CLASS 1 MODIFICATIONS TO THE HANFORD FACILITY RESOURCE CONSERVATION  
AND RECOVERY ACT PERMIT, QUARTER ENDING DECEMBER 31, 2010

**CLASS 1 MODIFICATIONS FOR QUARTER ENDING DECEMBER 31, 2010**

**Hanford Facility RCRA Permit Modification Notification Forms**  
**Part III, Operating Unit 3**  
**Liquid Effluent Retention Facility and 200 Area Effluent Treatment Facility**

Figure 3 Mercury Gas Monitor Probe Flange Connection

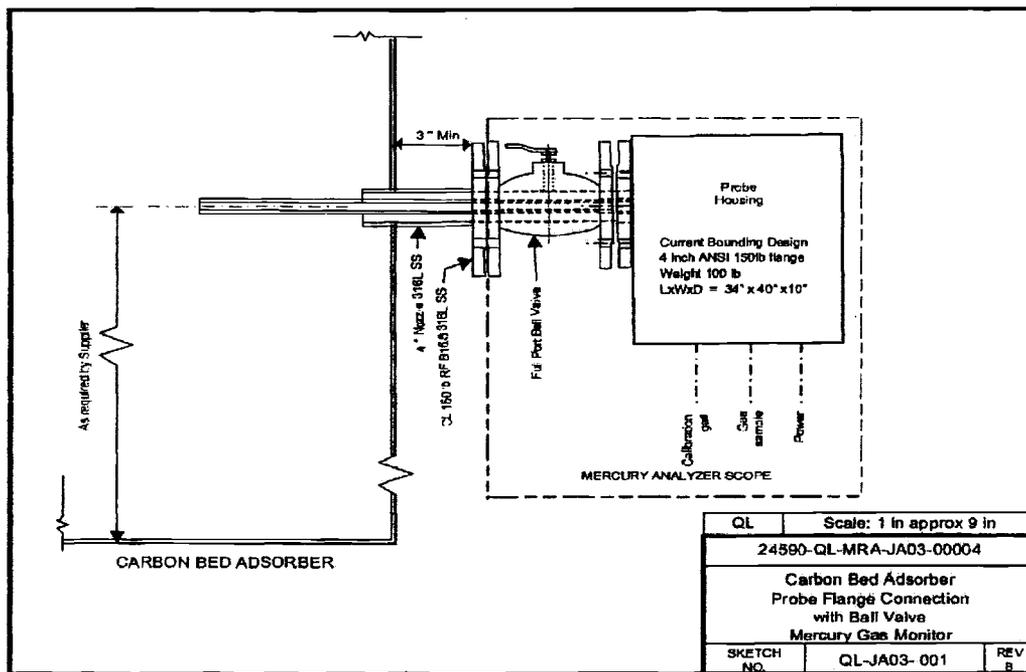
- Delete.
- Mercury monitor sample tap from each Activated Carbon Bed Adsorber with common return for Buyer supplied mercury analyzer. See Figure 3 for Mercury monitor sample tap requirements.
